Permit Application Review Report
Date: 3/4/2026

Project Name: South Shore Estates Second Addition

Project PAN: P-25-038

Project Purpose: residential development with streets, utilities and associated stormwater management features

Figure 2: Site Plan

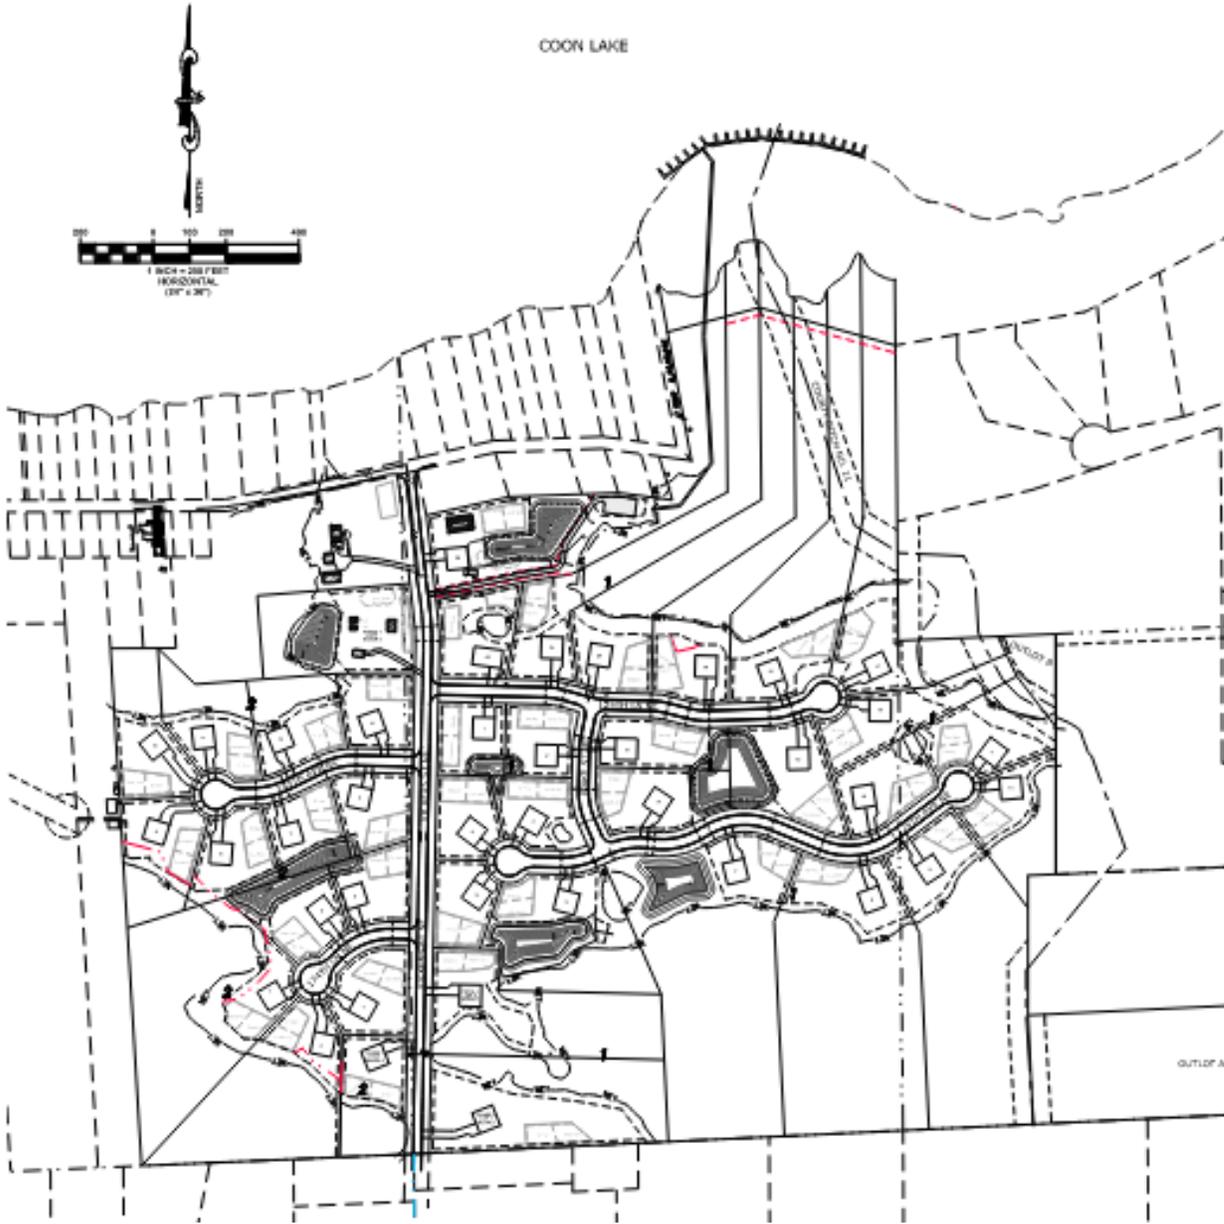
2. Please update the Soil Amendment Plan on sheet C2.3 to show the full extents of the amended areas within subcatchment 5.

Figure 3: Soils and Erosion Control

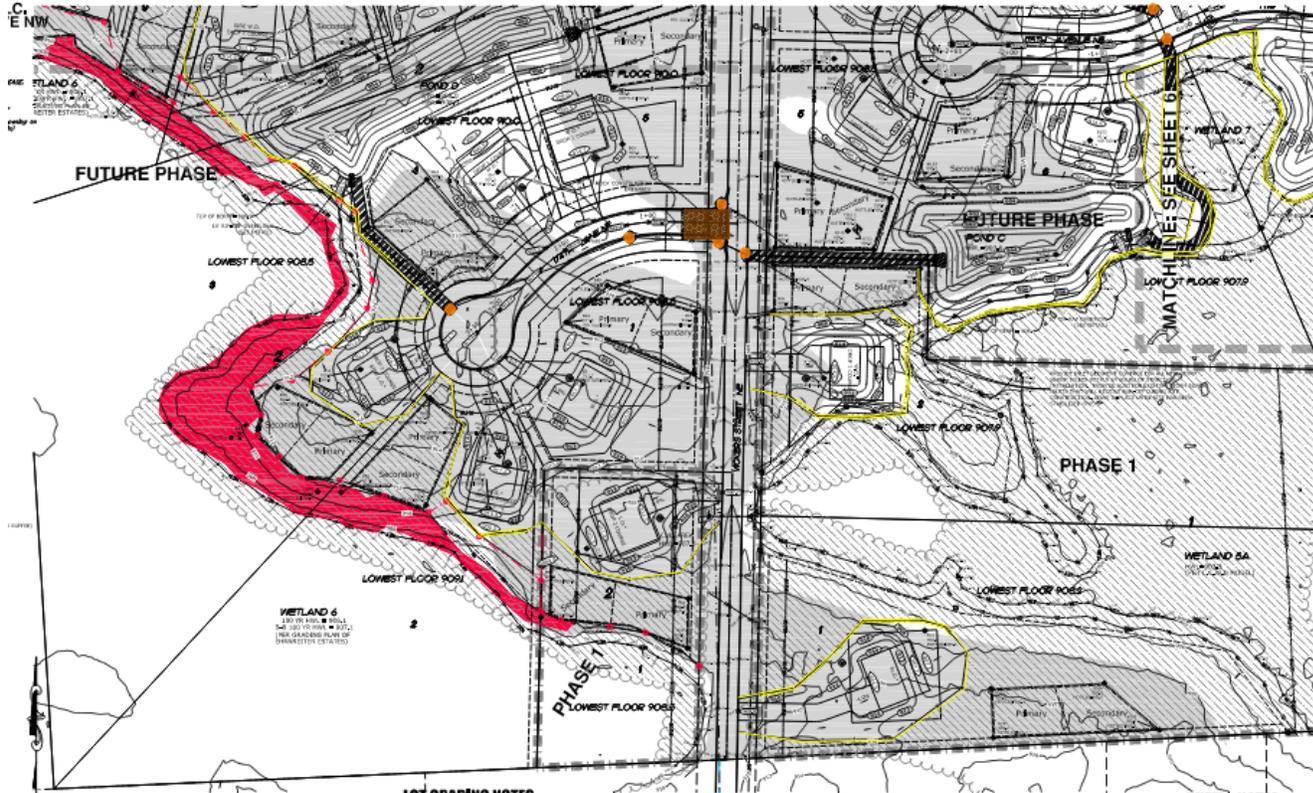
3. Provide redundant perimeter control around Wetland 8.

The proposed project drains to County Ditch 11 and the Sunrise River Water Management Organization. The soils affected by the project include Zimmerman, Lino, Rifle, and Isanti and do not have a soil erodibility factor of 0.15 or greater. Disturbed areas are proposed to be stabilized within 7 days, as required. The proposed erosion and sediment control plan includes perimeter control, inlet protection, street sweeping, and stabilized construction entrances. The erosion control plan meets District Requirements. The site does require an NPDES permit. See attached Figure 3: Soils and Erosion Control.
